Correct Orientation of OnGuard Collision Mitigation System on specific Jayco Motorized - Entegra - Cornerstone Class A Motorhomes

2017 Cornerstone Class A Motorhomes

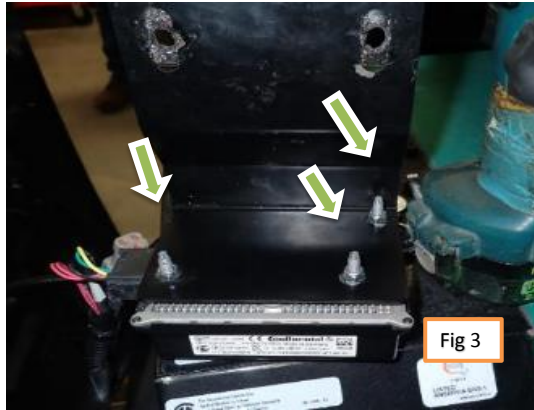
- Fig 1:** Open generator compartment.  
Locate the OnGuard Radar System computer.

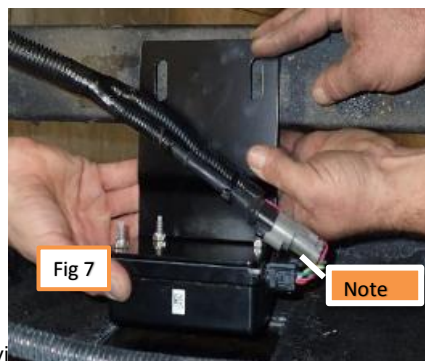
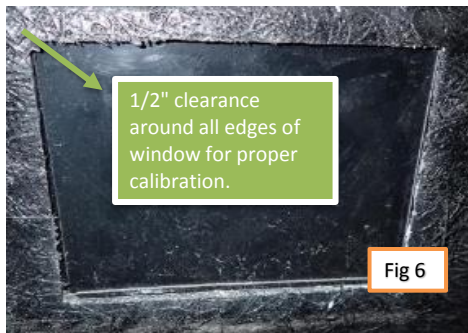
- Fig 2:** Remove bolts connecting the computer system to the compartment door (save bolts for reinstall).  
**Note:** Wiring harness is on the passenger side of the system. Confirms incorrect orientation.

3 Fig 3-4: Remove the bracket from the back of the computer system and discard bracket.
